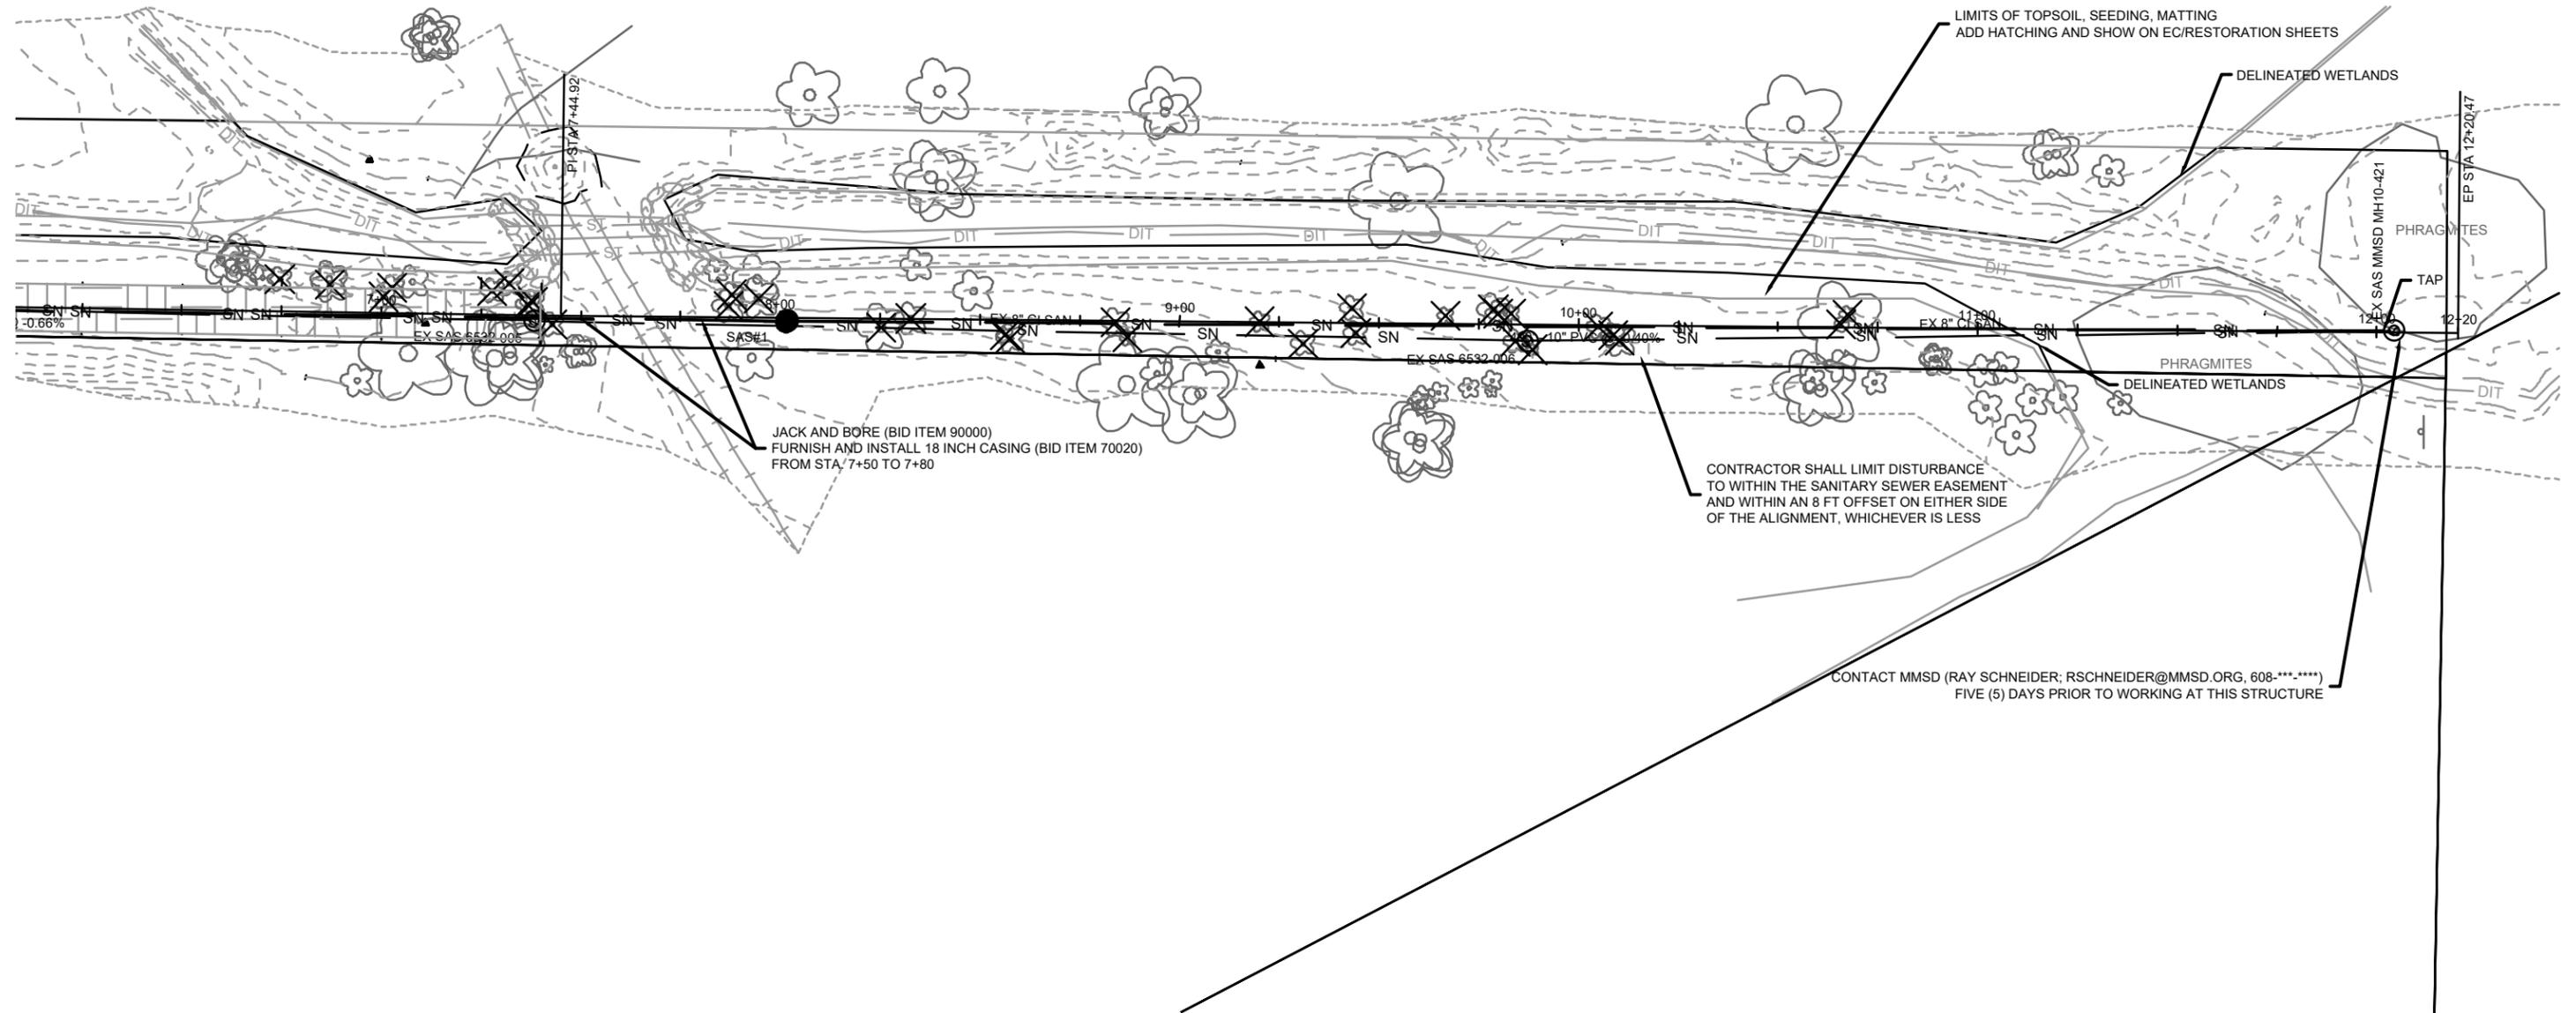
RECONSTRUCT BENCH AND FLOWLINES

RECONNECT EXISTING 6" PVC LATERAL

LIMITS OF TOPSOIL, SEEDING, MATTING (LAYER C-EROS)
ADD HATCHING AND SHOW ON EC/RESTORATION SHEETS

LIMITS OF TOPSOIL, SEEDING, MATTING
 ADD HATCHING AND SHOW ON EC/RESTORATION SHEETS
